MOORE-SUSSEX PLACE ESTATES SUBDIVISION

Engineering Comments: FINAL PLAT COMMENTS (should be addressed prior to submitting the FINAL PLAT for acceptance and signature by the City Engineer):

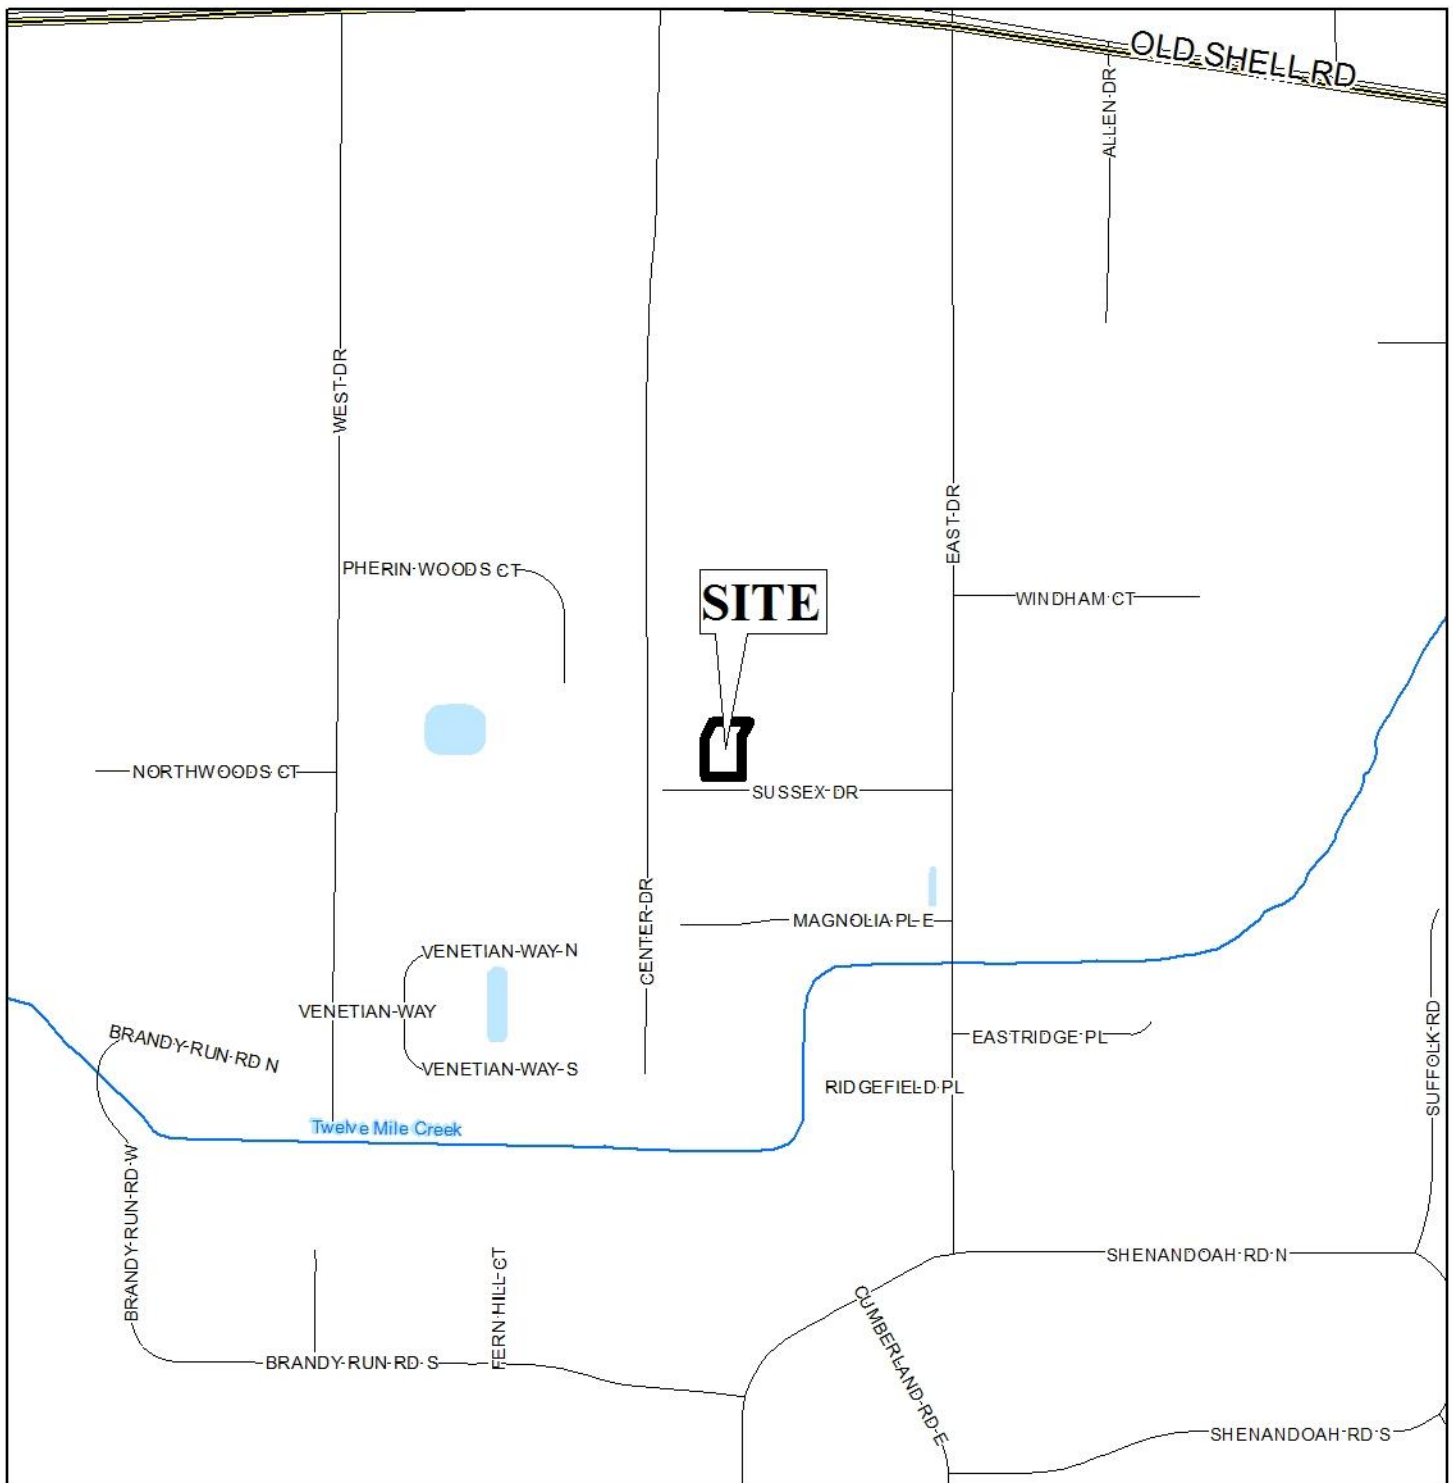
The proposed 80'± wide, 9,130± square feet lot has frontage on Sussex Drive, a minor street with curb and gutter requiring a right-of-way width of 50 feet. The preliminary plat illustrates an existing right-of-way width of 50 feet; therefore, no additional dedication should be required.

It should be noted that the proposed lot is accessed via a private alley in the rear of the property, the result of an 18' reciprocal easement; and, as such, access to Sussex Drive should be denied.

The proposed lot meets the minimum size requirements of Section V.D.2. of the Subdivision Regulations and is illustrated in both square feet and acres. This information should be retained on the Final Plat, or a table furnishing the same information should be provided on the Final Plat, if approved.

The 25-foot minimum building setback is illustrated on the preliminary plat. If approved, this information should also be retained on the Final Plat.

With regards to a note on the preliminary plat stating the lots are approved for 0' side yard setbacks, the subdivision was originally approved at the November 1, 1979 meeting of the Planning Commission prior to the adoption of regulations regarding Planned Unit Development; and, as such, similar approval of reduced side yard setbacks may be appropriate. If approved, the note should be retained on the Final Plat.

In addition to the aforementioned reciprocal easement, there is a 150 s.f. utility easement behind the 25' minimum building setback line along the East property line of the proposed lot, a 5' easement within the 25' minimum building setback line, and a 5' gas line easement in the rear of the proposed lot. As such, a note should be placed on the Final Plat, if approved, that no structures will be erected in any easements.

- 1) placement of a note on the Final Plat stating that the lot is denied access to Sussex Drive;
- 2) retention of the lot sizes in square feet and acres on the Final Plat, or the furnishing of a table on the Final Plat providing the same information;

- 3) retention of the 25' minimum building setback line on the Final Plat;
- 4) a note placed on the Final Plat stating that no structures will be erected in any easements;
